Description and Operation

General information

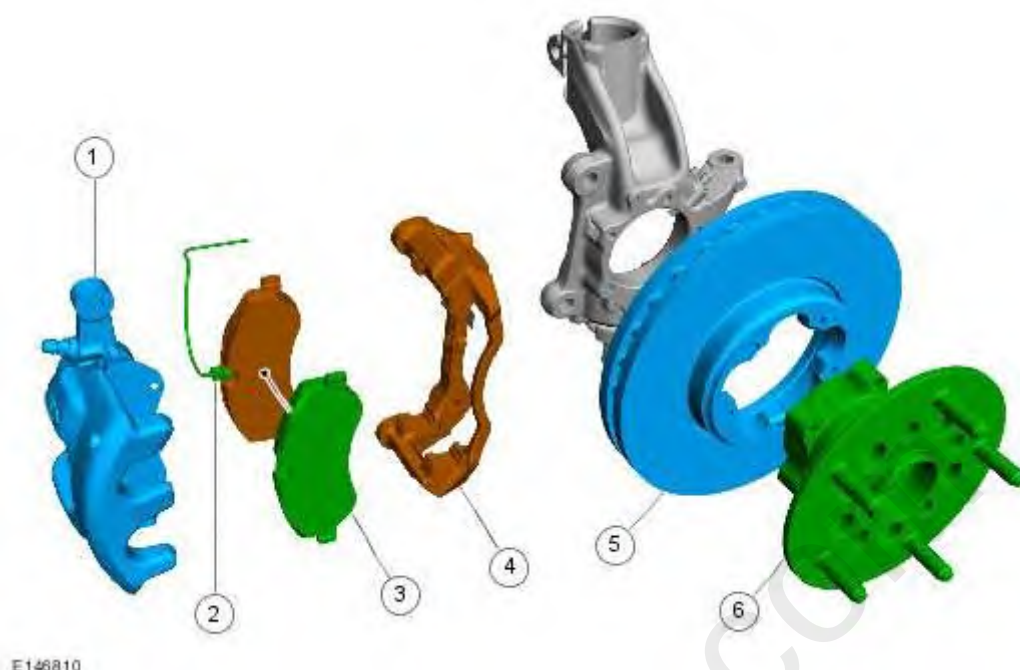
On the new Transit Custom, there is a brake pad wear indicator on one brake pad of each brake. This is a new feature compared with the previous model, on which respectively only one brake was monitored.

A further change compared with the previous model is the dimension of the brake disc, which is as follows:

- 288x33 mm for all models up to and including the 310 series
- 308x33 mm for models of the 330 series
